| Model: Katana                                     |   | Date:14-Jul-06  | No.: RB234015  |
| Subject: Service Manual Revision                  |   | Prepared by: S. Ishizu  |  |

**This document summarizes the corrections in the Service Manual for “Katana” (Machine Code: B234/235/236).**

## 11. Corrected the ELECTRICAL COMPONENTS <Page: B836-22>

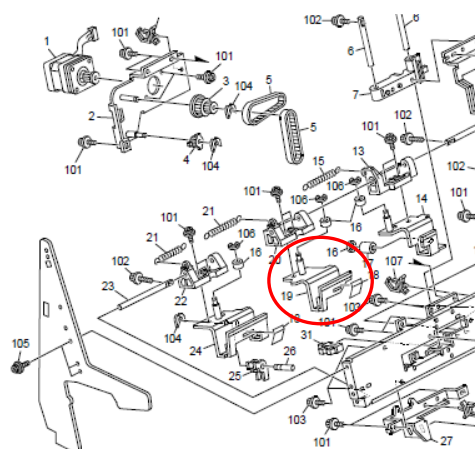
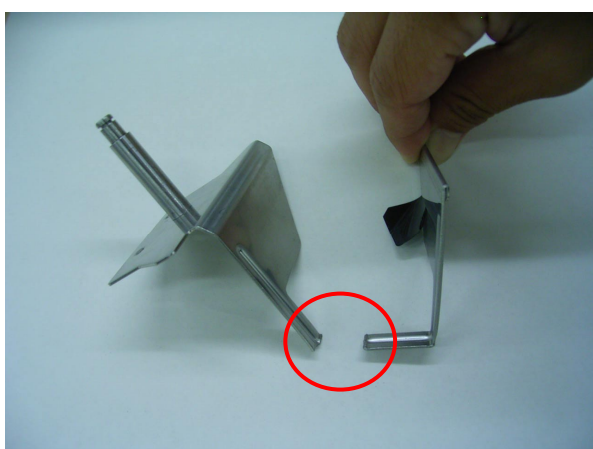
| 1. Horizontal Transport Sensor          | 10. Positioning Roller Motor                   |
| 9. Main Board (PCB)                     |  |

| 1. Horizontal Transport Sensor            | 10. <b><u>Main Board (PCB)</u></b>             |
| 9. <b><u>Positioning Roller Motor</u></b> |  |

| Subject: SR5000 Staple Rear Fence Broken          |   | Prepared by: M. Matsuda   |  |

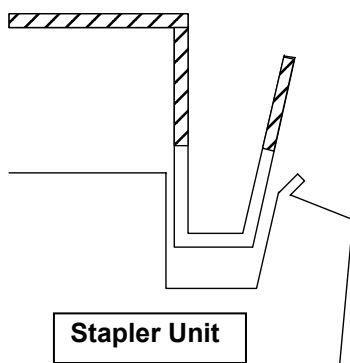
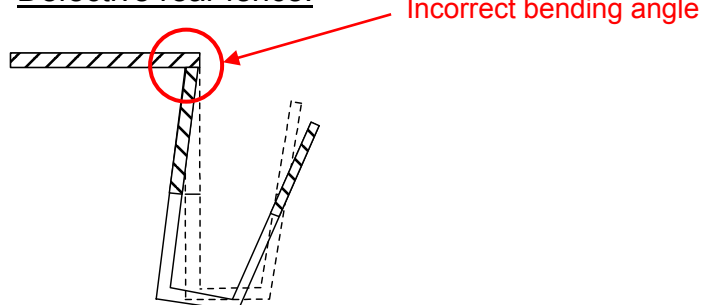
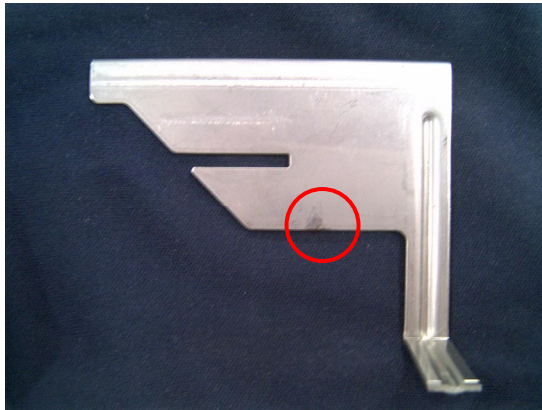
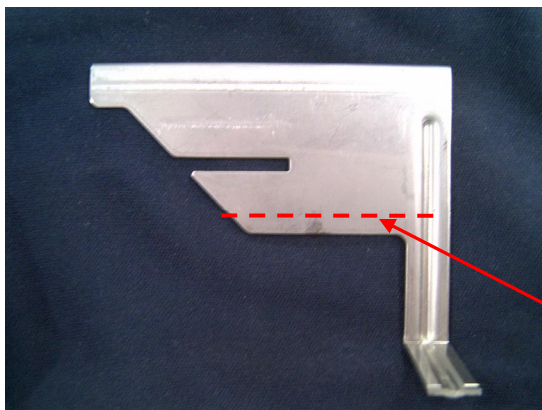
The rear fence for the SR5000 staple tray (P/N: B8304521) breaks, as shown below.

The bending angle of the rear fence was incorrect from the time of production. As a result, the stapler head may hit the rear fence repeatedly during stapling.

- The part of the rear fence that can contact the stapler head will be removed.
- A new factory inspection will be added for the rear fence.

This area  
will be  
removed

Check the rear fence at the next service visit, and replace the rear fence with a inspected rear fence (P/N **B2349905**, FOC) under these conditions:

- If there is a mark on the rear fence where the stapler head has hit it
- If this symptom has occurred

**Note:** The shape of the inspected rear fence mentioned above (P/N **B2349905**) is not changed. It only has an inspected bend angle.

| Subject: Provision for miss staple in SR5000 |   | Prepared by: T.Mimura                     |  |

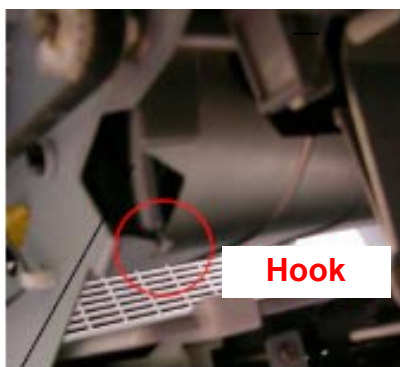
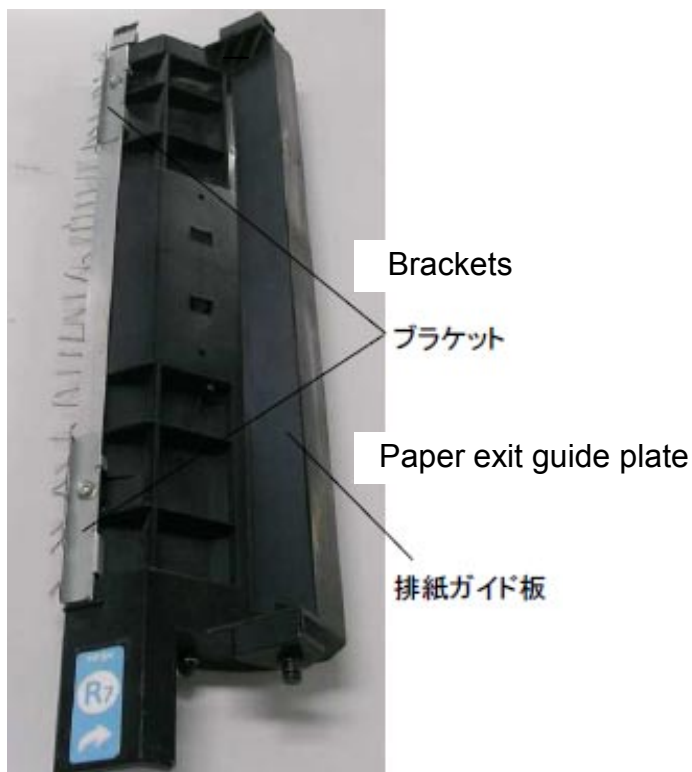
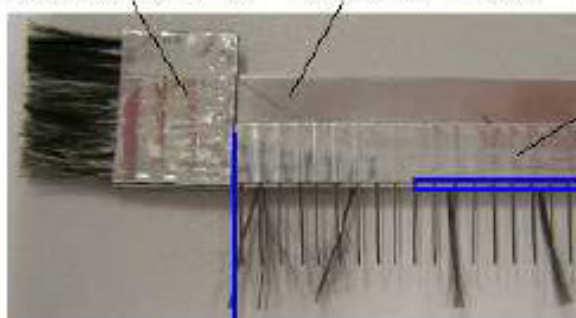
When stacking the papers in the stack unit, a few sheets don't get adjusted correctly so some sheets don't get stapled.

Paper sticks together because of static electricity.

Attach the Discharge Brush "B3011216" for Static Electricity Reduction.

4. Remove the paper exit guide plate from the frame.  
Then remove the screws (front & rear) that hold the bracket and the discharge brush.  
(The bracket and discharge brush are fastened with the same screws.)

5. Attach "B3011216" (discharge brush for individual support) as shown in the photo below, then fasten it with the bracket to the paper exit guide plate.  
*Attaching Position of the Discharge Brush (for individual support)*

Set flush with  
A6972131  
(Space to be  
within 1 mm)

## 17.Paper Exit Section 2 (B830)

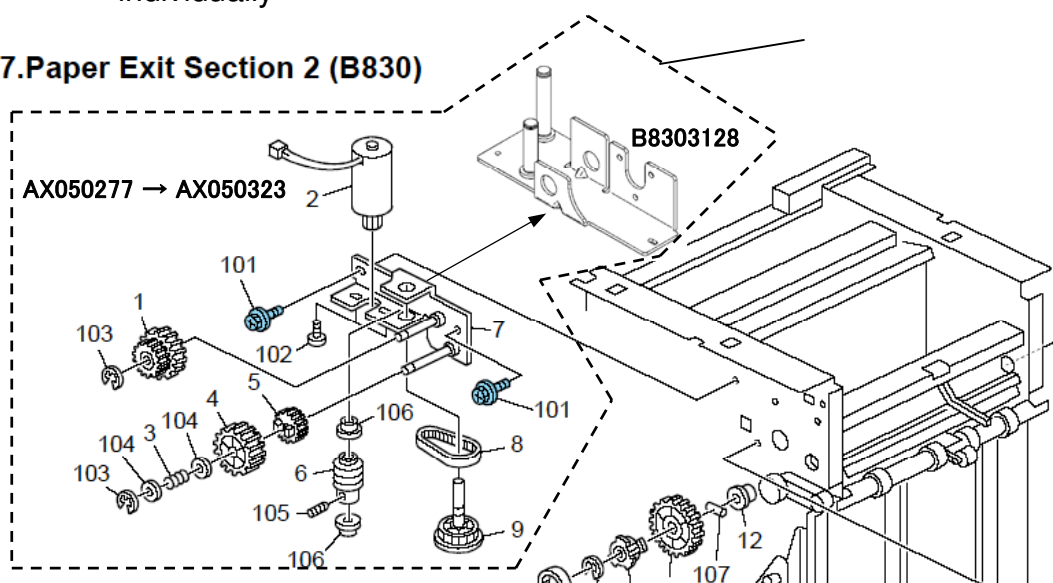
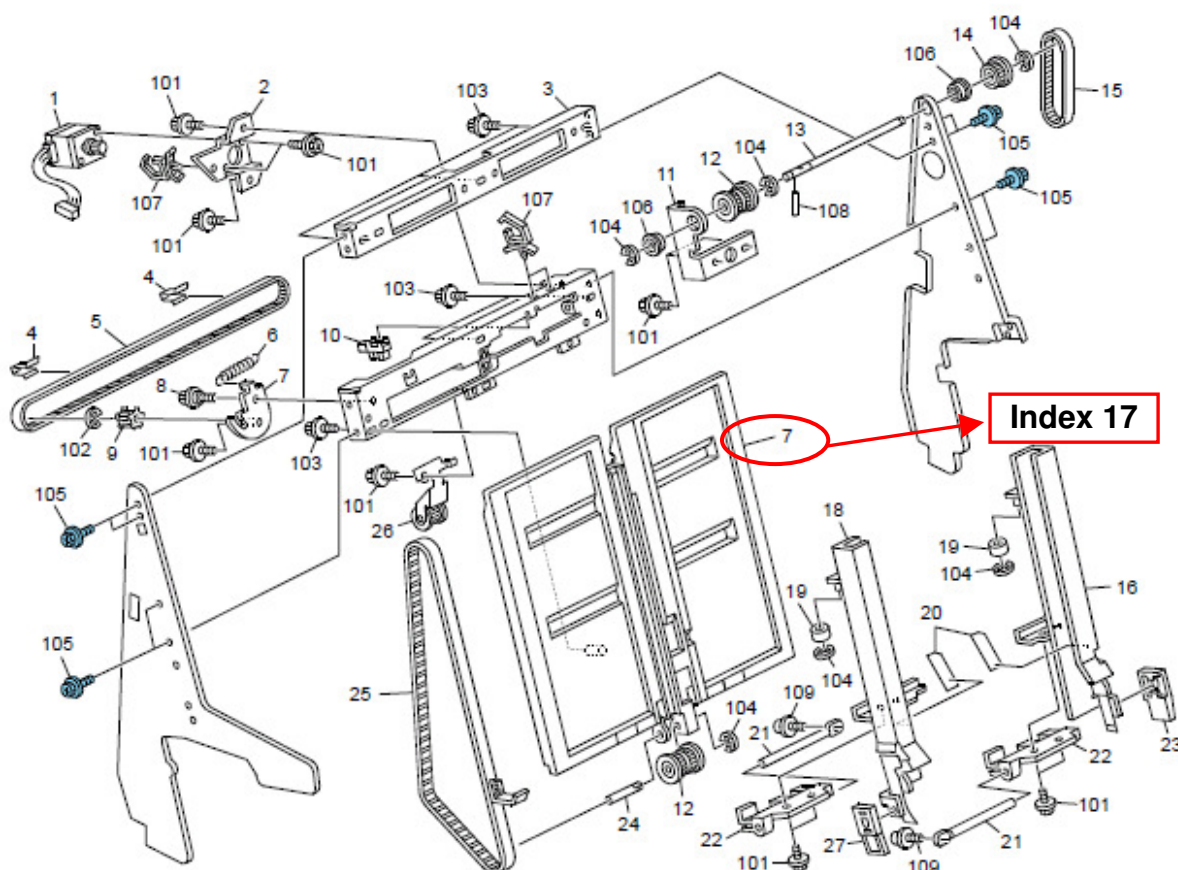
**Change:** The motor and bracket have been changed to new ones.

The screw number for attaching the motor has been changed 2 to 3.

**Remarks:** When changing the motor from AX050277 to AX050323, you must change the Bracket from B8303118 to B8303128 at the same time.

After you replace both of the above, you can replace either a Motor or a Bracket individually

## 15.Staple Transport 6 (B830)

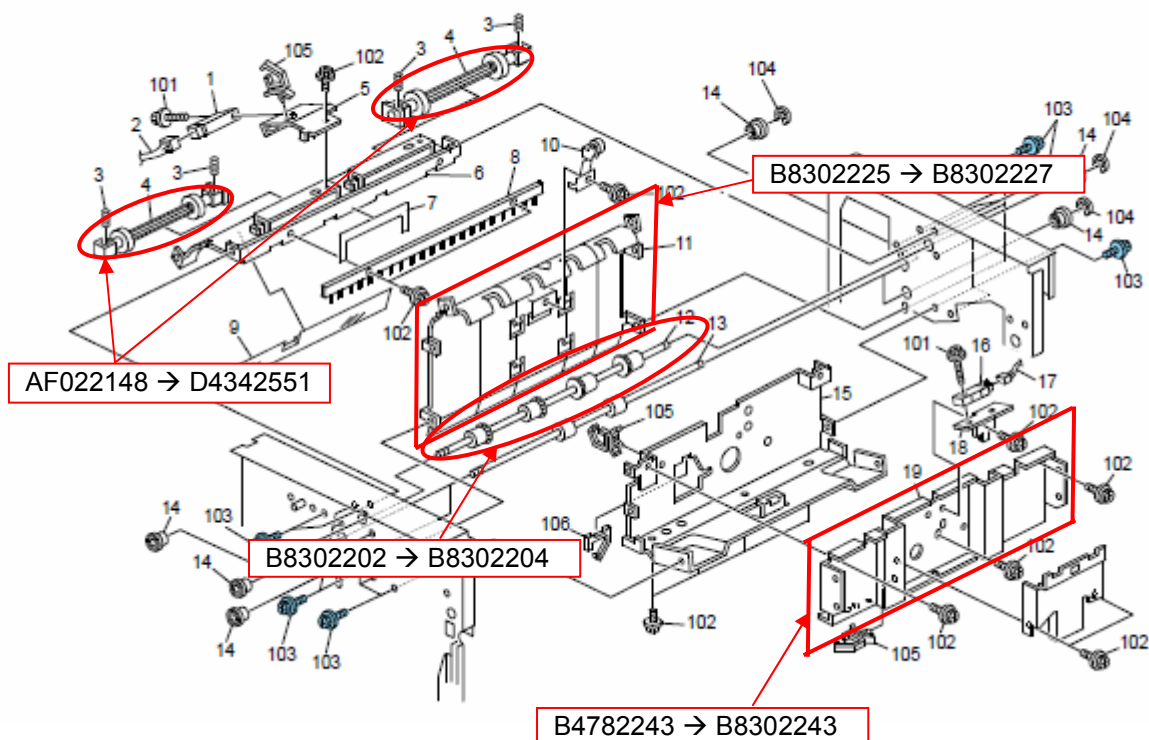
**Change:** Rollers that feed out paper to the Shift tray and the Proof tray were modified.

**Reason:** To prevent roller marks when feeding paper out to the Shift and Proof trays.

Replace B8302225 with B8302227.

When replacing AF022148 with D4342551, also replace AA080237 as a set.

16.Paper Exit Section 1 (B830)

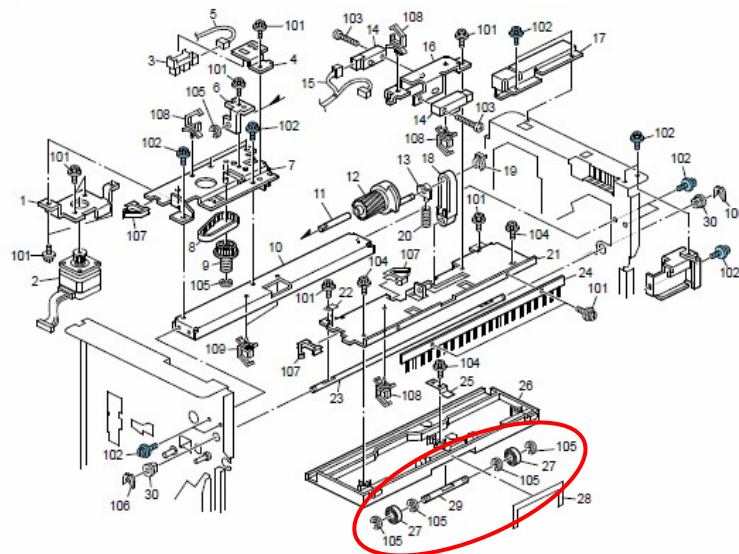
| Old Part Number | New Part Number | Description                            | Q'ty | Int | Page | Index | Note    |
|-----------------|-----------------|--|------|-----|------|-------|---------|
| C3082324        | D4342458        | EXIT ROLLER: DRIVEN: SHIFT TRAY: ASS'Y | 1    | X/X | 39   | 29    | -       |
| B8302324        | -               | EXIT ROLLER: DRIVEN                    | 2    | -   | 39   | 27    | Deleted |

18.Paper Exit Section 3 (B830)

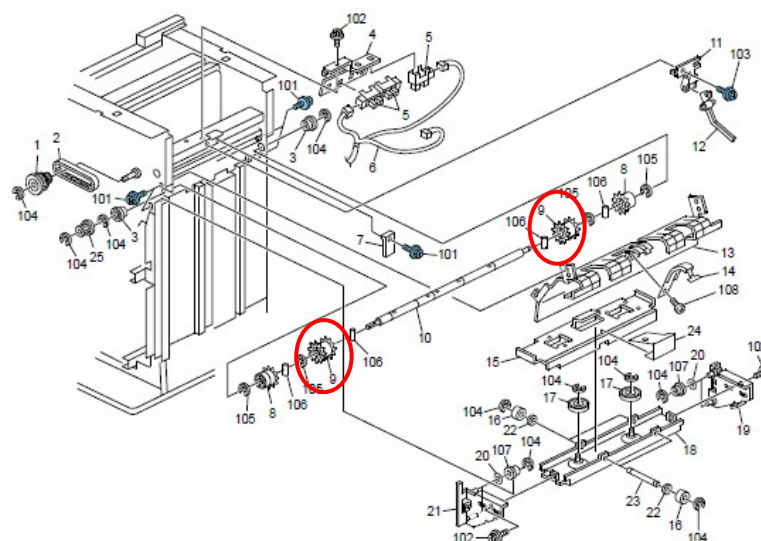
| Old Part Number | New Part Number | Description              | Q'ty | Int | Page | Index | Note |
|-----------------|-----------------|--------------------------|------|-----|------|-------|------|
| B8302302        | D4342474        | ROLLER:EXIT ROLLER:SHIFT | 2    | X/X | 43   | 9     | -    |
